## ADDENDUM

SUBJECT: **ADDENDUM TO ITEM TH14B, DE NOVO APPLICATION NO. A-5-VEN-20-0037 FOR THE COMMISSION MEETING OF THURSDAY, FEBRUARY 11, 2021.**

### Exhibit 3– Revised Project Plans (dated February 8, 2021)

FLOOR AREA CALCULATIONS

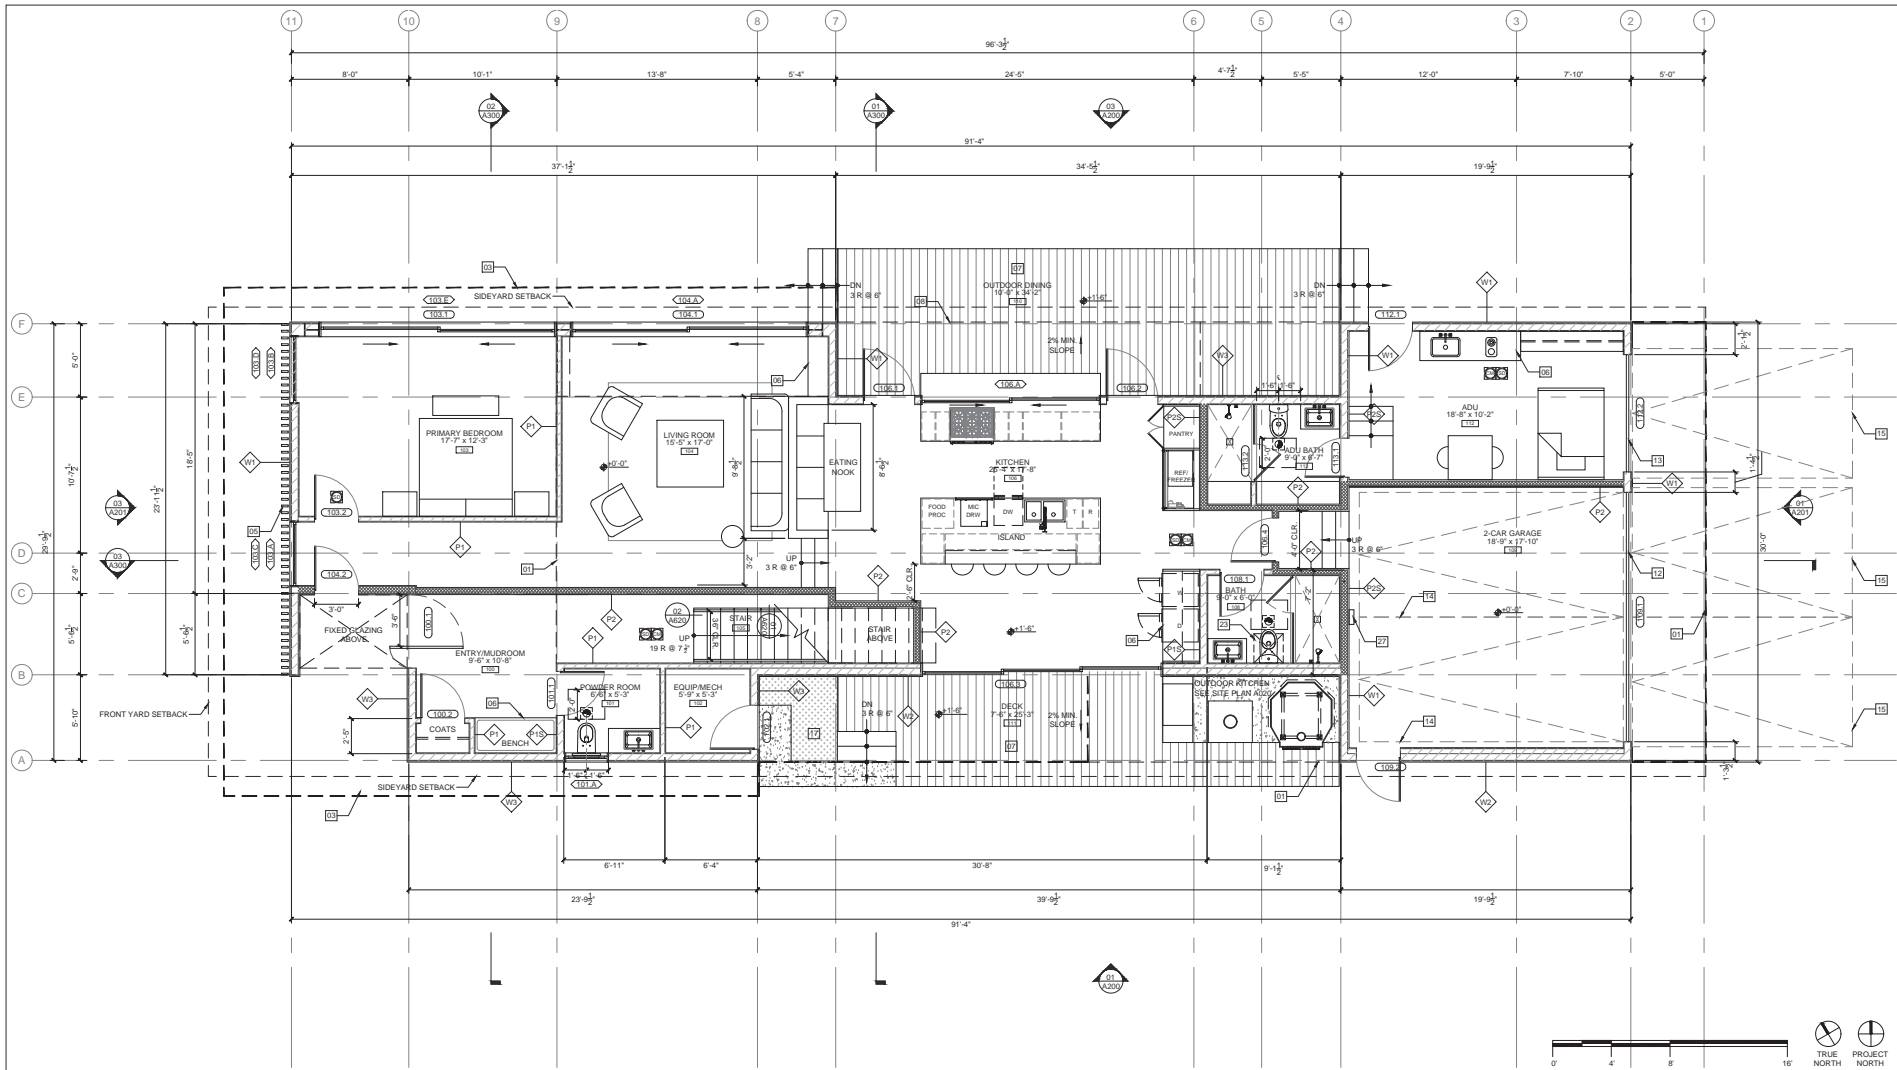
**(4) The project plans show discrepancies in estimated areas and setback lengths, as well as mis-labeled or missing amenities throughout the units.** The applicants have submitted plans (dated February 8, 2021) revised to correct inaccuracies and more clearly show the location of the proposed bathrooms and dining areas throughout the units. It is important to note that these revised plans have not altered any of the area estimations proposed with the plans dated January 19, 2021. The plans dated February 8, 2021 shall replace the plans included in Exhibit 3 of the staff report and are attached to this addendum. Commission staff have also compiled the following table, which lists relevant parameters of the existing and proposed development:

FIRST FLOOR PLAN

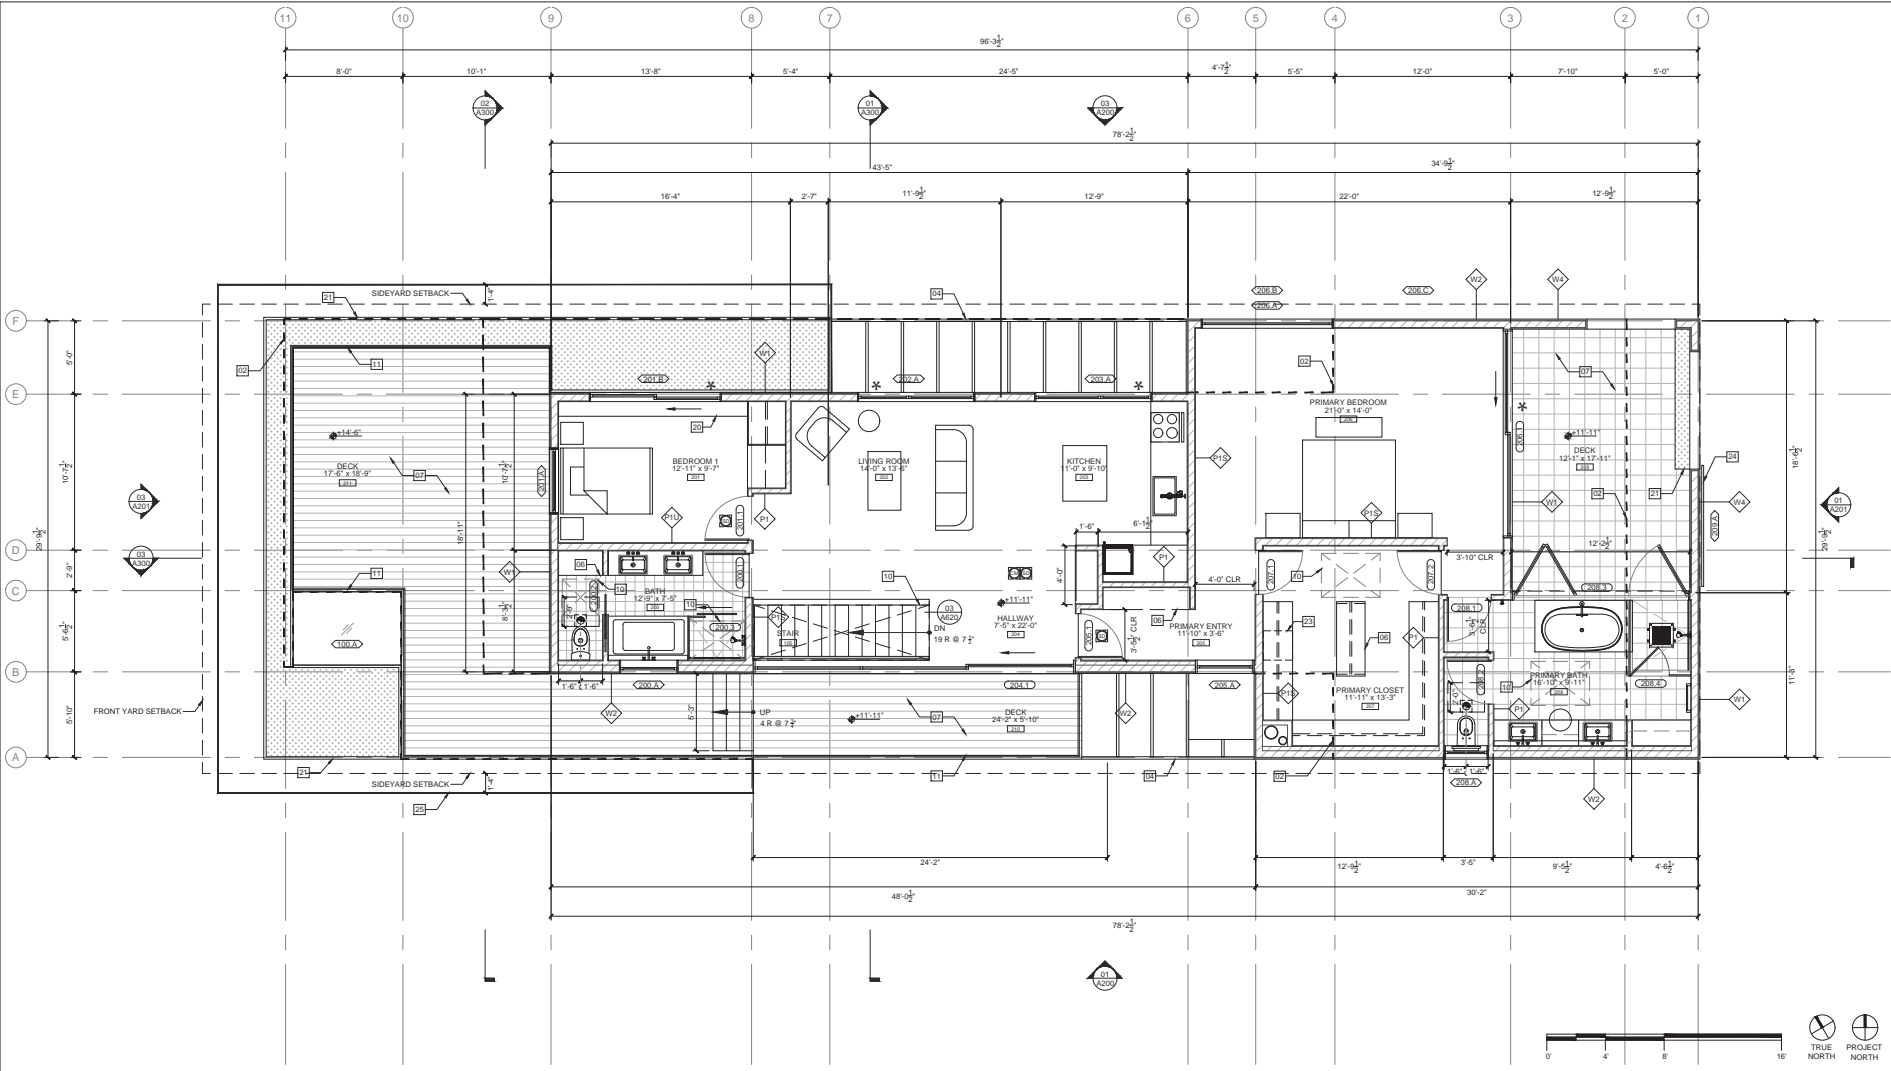
**(3) The proposed parking configuration on-site is infeasible and will likely require residents to park off-site.** To address this concern, the project applicant has submitted the following description of the five parking spaces proposed within the rear-yard on-site:

“Unit 1 and Unit 2 share an enclosed garage. Each unit has one assigned standard parking space within this enclosed garage. Each unit also has one uncovered compact parking space which sits in tandem, immediately behind that unit’s standard parking space, outside of the garage. There is one compact guest parking space adjacent to the assigned tandem spaces. The back up aisle for all of these spaces can be adequately provided by the 15’-0” alley behind them.”
